From: [Lowman, Donald](#)
To: [Royal Pond](#)
Cc: [Von Till, Bill](#); [Saxton, John](#); [Quintero, Jessie](#); [Mike Griffin](#)
Subject: Strata Energy 11.3(C) Amendment Request
Date: Tuesday, November 28, 2017 11:32:00 AM
Attachments: [Amendment 8 SER V1_Rev6.docx](#)

SAFETY EVALUATION REPORT
REVIEW OF APPLICATION TO AMEND LICENSE CONDITION 11.3(C), LICENSE SUA-1601,
STRATA ENERGY, INC. ROSS IN SITU RECOVERY FACILITY, CROOK COUNTY, WY

DOCKET NO.: 040-09091

Figure 1. Well Yields of 0.5 GPM as a Function of Available Water Column, Transmissivity and Storativity

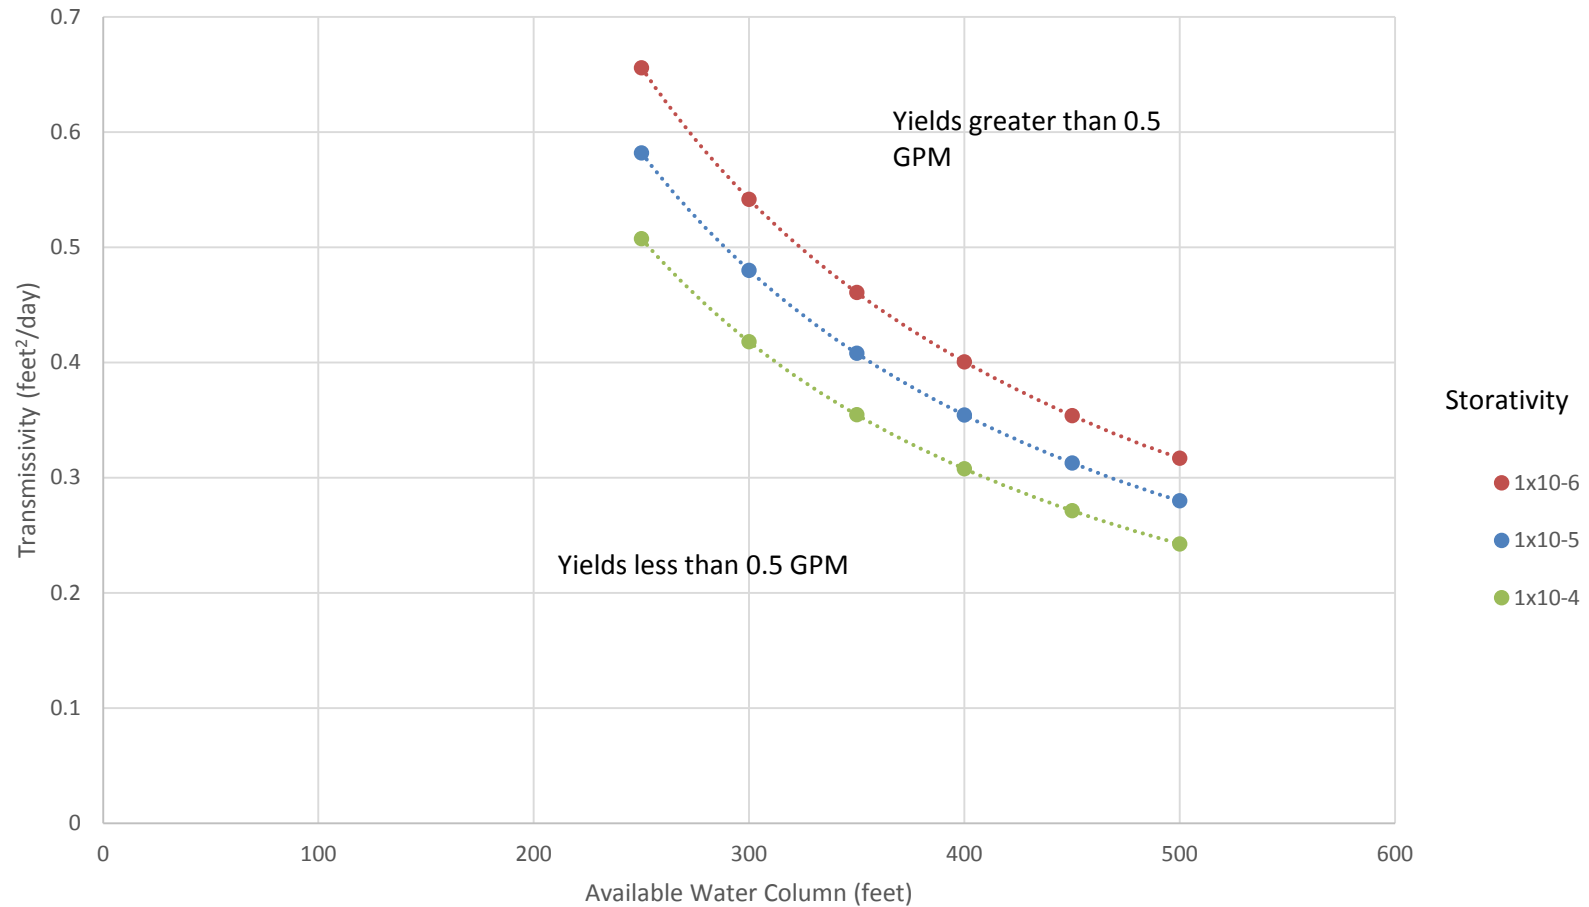
The NRC staff finds Strata's proposed criterion 5 acceptable because it is based on established State of Wyoming criteria. Furthermore, staff find the procedures used by Strata acceptable (with one caveat listed below) because they quantify a sustainable yield for a specific well based on (1) estimates of the hydraulic properties for the aquifer in the vicinity of the well using established slug testing methodology, (2) an appropriate period for sustainable pumping, (3) utilizing actual water column in the pumping well available for cumulative drawdown, and (4) established models for non-equilibrium radial flow to a well. The assumed parameters for Strata's analysis include storativity of the aquifer (1×10^{-5}), estimated available water column with a factor of safety (20 feet above the pump intake which is 30 feet above the top of the screened horizon) and the pumping duration (365 days). The measured parameters for Strata's analysis include radius of the well screen (0.4375 feet), radius of the well casing (0.1875 feet), aquifer thickness (13 to 25 feet), available water column (static water elevation minus the maximum safe drawdown elevation) (205.8 to 493.9 feet) (Strata, 2017c). The calculated parameters for Strata's analysis include transmissivity of the aquifer and well yield. The NRC Staff finds that the assumed and measured parameters are appropriate and confirmed that Strata's calculations for the well yield are correct using Strata's assumed, measured and calculated parameters (Table 1).

Figure 2. Examples of Curve Fitting to Strata’s Data and Estimation of Time to 0.25 Recovery

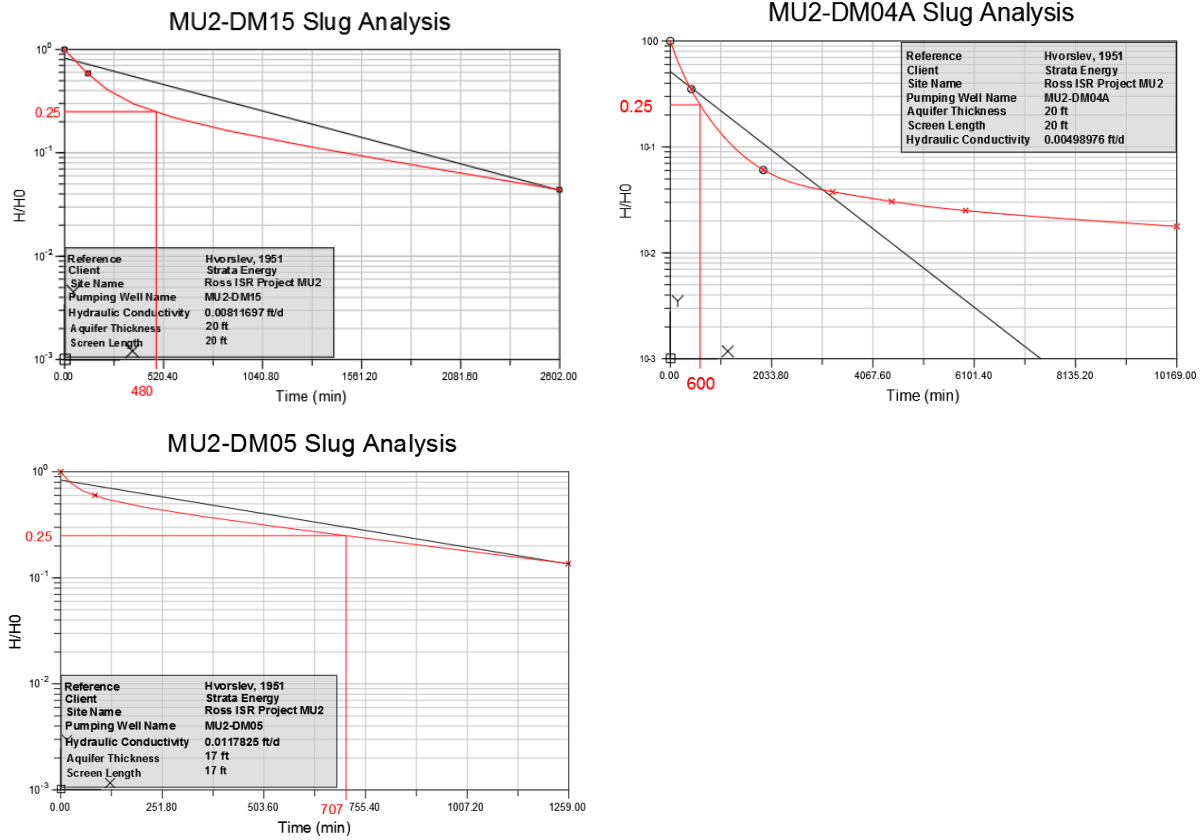
To establish whether Strata's proposal to eliminate any wells from monitoring was based on a flawed analysis, the NRC staff verified Strata's calculations by using the Cooper and Papadopulos methods to establish a transmissivity. The method typically consists of fitting the observed data to a model type curve and then establish a match point between the observed time and dimensionless time for the model curve (Dawson and Istok, 1991; Fetter, 1980). Because of the limited data, the NRC staff used a variant of the method by obtaining a match point for a selected normalized head. In this case, the NRC staff used a normalized head that was 25 percent of the initial head. To establish the normalized 25 percent head, curves were fitted to the data using Strata's graphs from the mine unit reports (for examples, see Figure 2).

In several cases, the limited data introduced an unacceptable degree of uncertainty in this analysis. If staff determined that Strata's data were insufficient for any analysis or the uncertainty in the curve assigned by staff yielded ambiguous results, then that well was eliminated from staff's verification process and, by default, included in the monitoring program.

The NRC staff determined that the data for wells MU2-DM01, MU2-DM05 and MU2-DM15 was insufficient or had sufficient uncertainty that the verification was deemed unnecessary and the wells were included in any proposed monitoring program. For the remainder of wells, the NRC staff estimated the time to the 25 percent normalized head varied between 0.2 and 13.7 days (Table 2).

Figure 4. Mine Unit 1 and 2 Wells exceeding the Yield Criterion

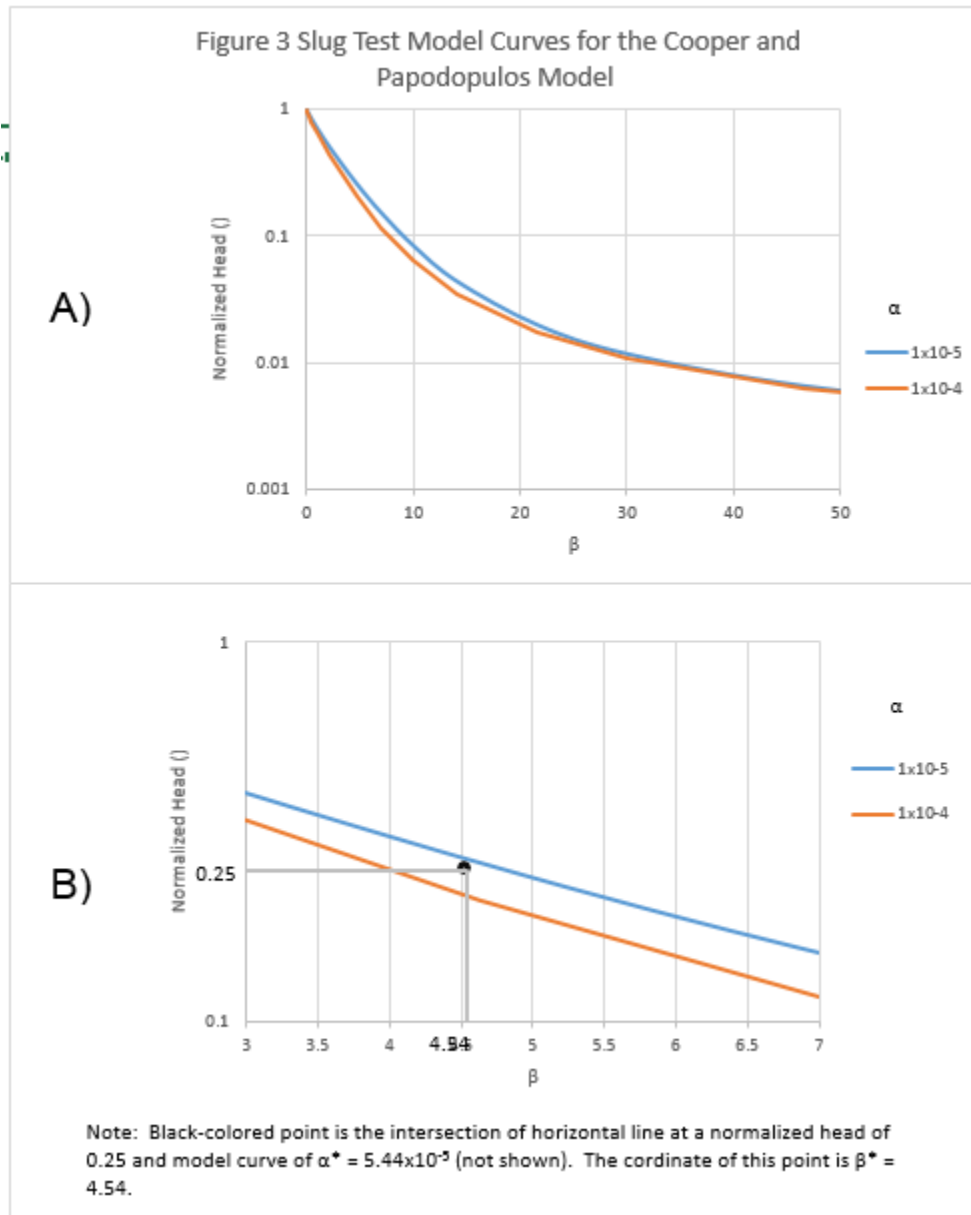
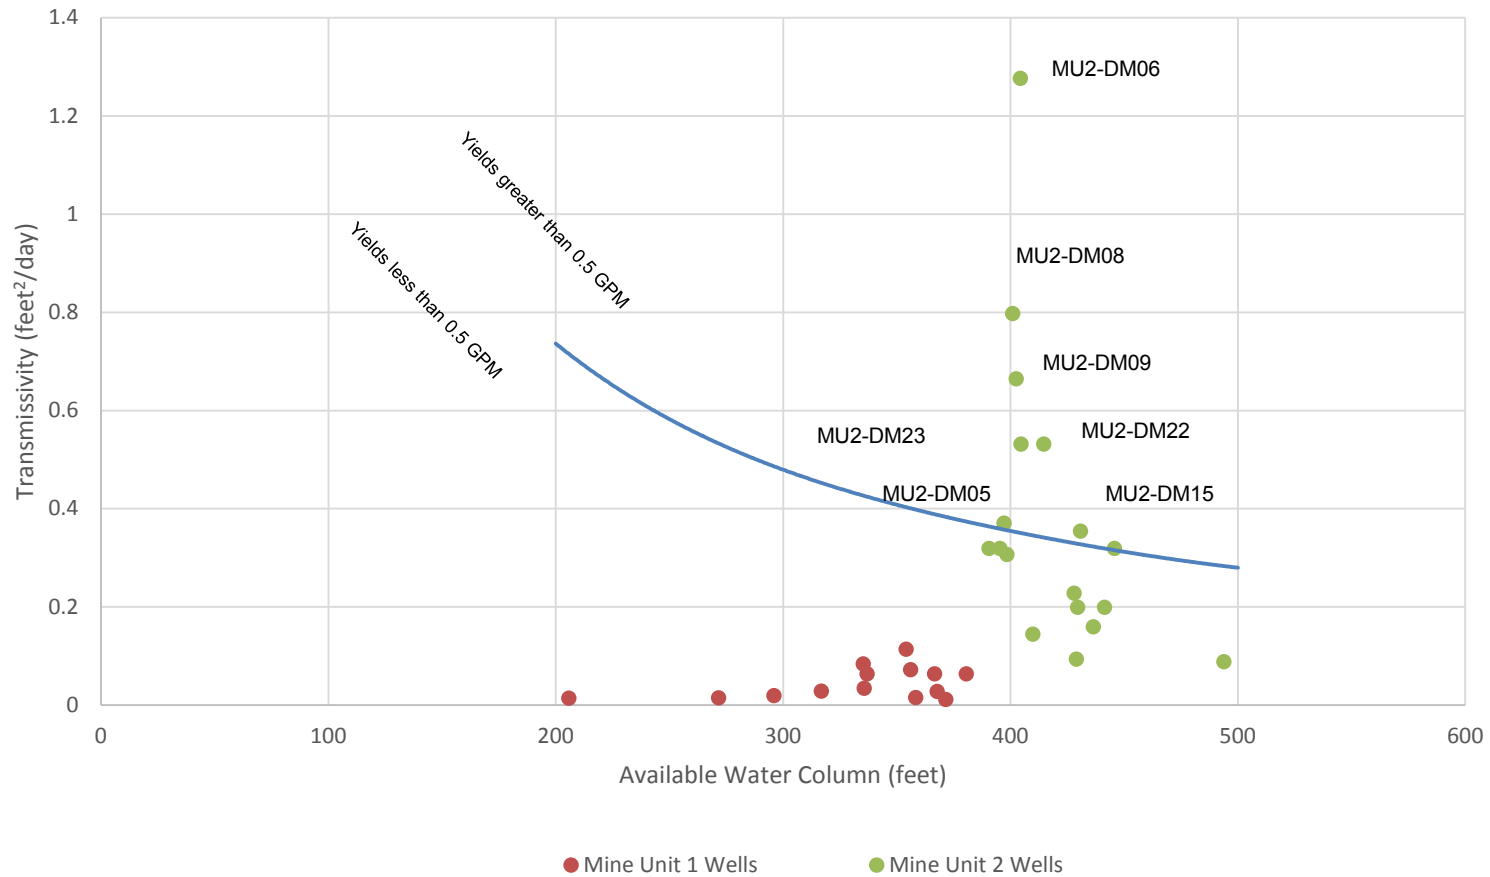
The calculated transmissivities through the verification process varied from 0.01 to 1.28 square feet per day (Table 2). Using the estimate of transmissivity developed through the verification process, a safe yield was determined for each well using the method described above (Table 2). The NRC staff's estimate of the transmissivity during the verification process was consistent with Strata's calculations (within 0.05 square feet per day) for all wells in Mine Unit 1 and wells MU2-DM02, MU2-DM11, MU2-DM14, MU2-DM16 and MU2-DM19. For wells MU2-DM04a, MU2-DM12a, MU2-DM17, MU2-DM18, MU2-DM20 and MU2-DM21, staff's verification transmissivity differed from Strata's calculation (greater than 0.05 square feet per day) but did not result in a predicted well yield greater than 0.5 gpm. For those wells, staff finds that that Strata's conclusions are valid (Figure 4). For wells MU2-DM-06, MU2-DM-08, MU2-DM-09, MU2-DM-22 and MU2-DM-23, staff's verification transmissivity resulted in a predicted well yield greater than 0.5 gpm and thus did not verify Strata's calculations.

Therefore, the NRC staff finds that all DM unit wells in Mine Unit 1, and the DM unit wells in Mine Unit 2 except wells MU2-DM01, MU2-DM-05, MU2-DM-06, MU2-DM-08, MU2-DM-09, MU2-DM15, MU2-DM-22 and MU2-DM-23, have a predicted yield less than WDEQ/LQD criterion of 0.5 gpm and recommends those wells be removed from the monitoring program as requested by Strata. Staff finds that predicted well yields for wells MU2-DM01, MU2-DM-05, MU2-DM-06, MU2-DM-08, MU2-DM-09, MU2-DM15, MU2-DM-22 and MU2-DM-23 cannot be verified and thus continued monitoring is required (i.e., Strata's request is denied for these wells). Strata may elect to re-perform slug tests at the wells that yield insufficient data and resubmit a request for staff to evaluate the new data in the future.

- Mine Unit 1: Monitoring at all wells is discontinued.
- Mine Unit 2: Monitoring is required at wells MU2-DM01, MU2-DM05, MU2-DM06, MU2-DM08, MU2-DM09, MU2-DM15, MU2-DM22 and MU2-DM23
